## ADDENDUM

**PROJECT:** Columbus Public Schools  
High School - Stage Floor Renovation  
Columbus, Nebraska

AD-2

**DATE ISSUED:** Friday, May 4, 2012

P 6  
A-101  
Orchestra Pit Filler Plan  
SCALE: 1/8" = 1'-0"

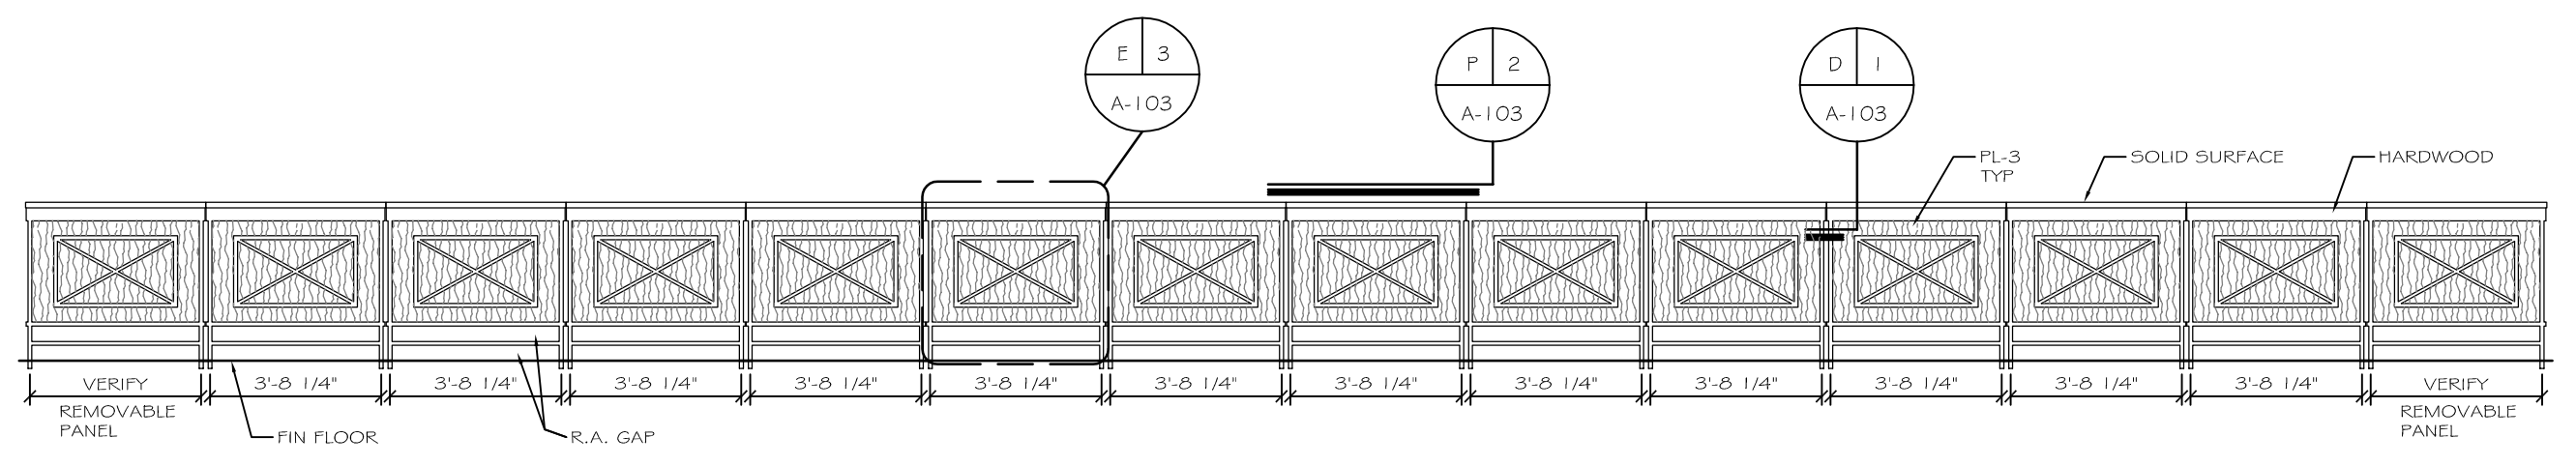
In reference to drawing Sheet A-101, Detail P4, see attached Supplemental Drawing A-103 for extent of new stage extension (orchestra pit filler) and orchestra pit replacement guardrail.

The approximate 5' high stage floor extension / orchestra pit filler shall consist of floor panel sections with removable, adjustable height support legs. The panels shall include recessed safety edge lighting with quick connectors for panel to panel continuity. See attached floor plan for configuration.

### Floor Plan - Electrical

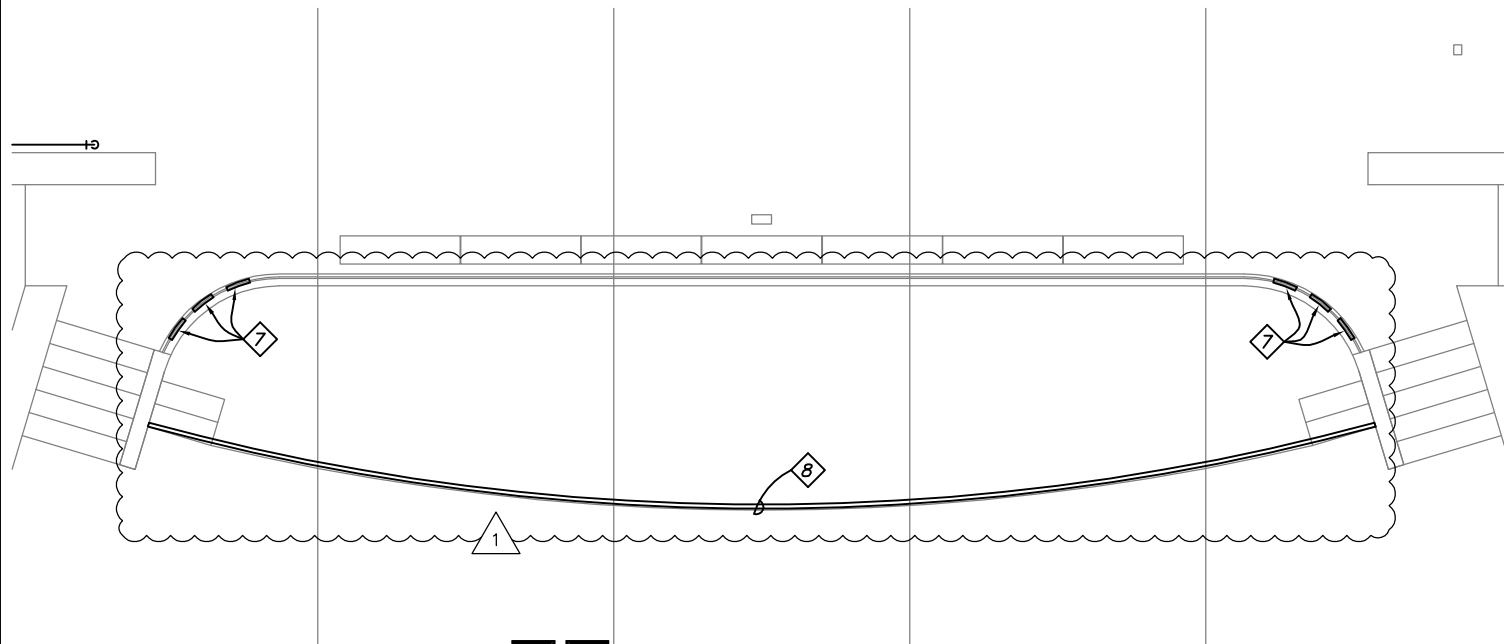
- 7** PROVIDE ONE 12" LONG SEGMENT OF STAGE EDGE LIGHT TO BE INSTALLED IN ROUTERED GROOVE IN EDGE TRIP. SEE DETAIL 2. DRILL THROUGH STAGE FLOOR TO PROVIDE ACCESS/ROUTE FOR WIRING. TIE INTO WIRING OF 40' LONG STAGE FRONT EDGE LIGHTING PRIOR TO THE QUICK CONNECTOR THAT WILL CONNECT THESE SEGMENT TO THE LED DRIVER. PROVIDE WIRING AS REQUIRED TO REACH CONNECTION POINT BELOW THE STAGE. SECURE ALL WIRING EVERY 36". LIGHT SEGMENT SHALL BE FUTURE LIGHT "EDGE LYTE HEL/F/12"/6/A/C. SEGMENT SHALL HAVE 2 LEDS.

- 1**
- 8** PROVIDE 4 FOOT LONG SEGMENT, ADJUSTED FOR FINAL LENGTH OF PIT FILLER PLATFORMS, TO BE INSTALLED IN A ROUTERED GROOVE IN THE TOP OF THE PLATFORM. COORDINATE WITH PIT FILLER MANUFACTURER. EACH SEGMENT SHALL HAVE 3' LONG WIRING ROUTED THROUGH THE PLATFORM AT EACH END, EXCEPT FOR FIRST SEGMENT, WHICH SHOULD HAVE 30 FOOT OF WIRING, AND LAST SEGMENT, WHICH SHOULD HAVE ONLY ONE END WITH WIRING, SO ALL SEGMENTS CAN BE CONNECTED TOGETHER BELOW THE PLATFORMS AND FORM A CONTINUOUS CIRCUIT. WHEN ALL CONNECTED, THIS STAGE EDGE LIGHT SHALL BE CONNECTED TO THE DIMMER SUPPLY AND THE PERMANENT STAGE FRONT EDGE LIGHTING CIRCUIT SHOULD BE DISCONNECTED. TOTAL LENGTH OF PIT FILLER STAGE EDGE LIGHTING CIRCUIT SHALL BE APPROXIMATELY 50'.
